10/529,714

REMARKS

The present Response is submitted in reply to the Office Action of February 16, 2007.

[001]DEVICE FOR THE OPTIMIZATION OF HYDRAULICALLY CONTROLLED ENGAGEMENT OF CLUTCHES USED IN MARINE TRANSMISSIONS

Fig. 5

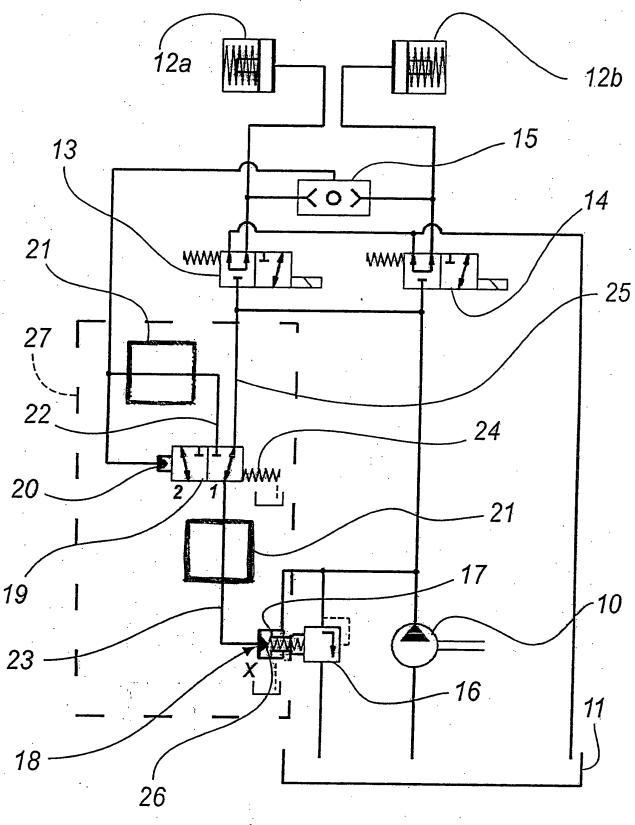
Next, the Examiner rejects claims 5-8 under 35 U.S.C. 112, first paragraph, for insufficient disclosure of the limitations and elements recited in the claims. In particular, the Examiner states that there is insufficient description of the structure of adjusting device 17 that allows oil to be discharged toward the clutch, as stated in lines 18-21 of page 9 of the specification. In response, the Applicant wishes to point out that, as described in Fig. 5 and in, for example, paragraphs [033], [034], [035] and [042] of the specification, the adjustment device 17 functions in conjunction with the control valve 16, which is connected between the pressure side of the pump 10 and the reservoir 11 and, as described at, for example, paragraphs [033], [034], [035] and [042], includes a spring element 18 and a piston 26. As clearly shown in Fig. 5, the piston 26 is acted upon by the spring element 18 and one side of the piston 26 is acted upon by the pressure in the output line from pump 10. The other side of the piston 26 is acted upon by the pressure in line 23 from the valve 21 and sequence the valve 19 and which leads either eventually to the bistable valve 15 and the pistons 12a and 12b of the clutch or to line 25 which is connected to the output of pump 10, depending on the state of the sequence valve 19.

Therefore, and as clearly shown in Fig. 5 and as described in paragraphs [033], [034], [035] and [042], the control valve 16, the piston 26 and the adjustment device 17 together comprise an adjustable pressure actuated valve whose actuation is dependent upon the pressure difference between the pressure on the output line from the pump 10 and the pressure present on line 23, which is connected either to the bistable valve 15 and the pistons 12a and 12b of the clutch or to line 25 which is connected to the output of pump 10, depending on the state of sequence valve 19.

of the description of the various operating states of the system in, for example, paragraphs [043] through [048], that this statement refers to the condition when sequence valve 19 is in the second state, that is, when the sequence valve 19 is switched so that line 23 is connected to the bistable valve 15 rather than to the output of pump 10, which is the situation when the sequence valve 19 is in the first state. As shown and described, line 23 and thus the piston 26 of the adjusting device 17 of the control valve 16 is then routed to and through the bistable valve 15 and to the pistons 12a and 12b of the clutch, so that the pressure in line 23, which is then determined by the pressures in pistons 12a and 12b, is reduced so that oil flows or drains, that is, is discharged, from the piston 26 of the adjustment device 17 of the control valve 16 and through line 23 towards the clutch.

It is therefore the Applicant's belief and position that the structure and operation of adjusting device 17, that enables oil to be discharged toward the clutch, has been fully and sufficiently described under the requirements and provisions of 35 U.S.C. 112, first paragraph. The Applicant, therefore, respectfully requests that the Examiner reconsider and withdraw all rejections of the claims, including claims 5-8, under 35 U.S.C. 112, first paragraph.
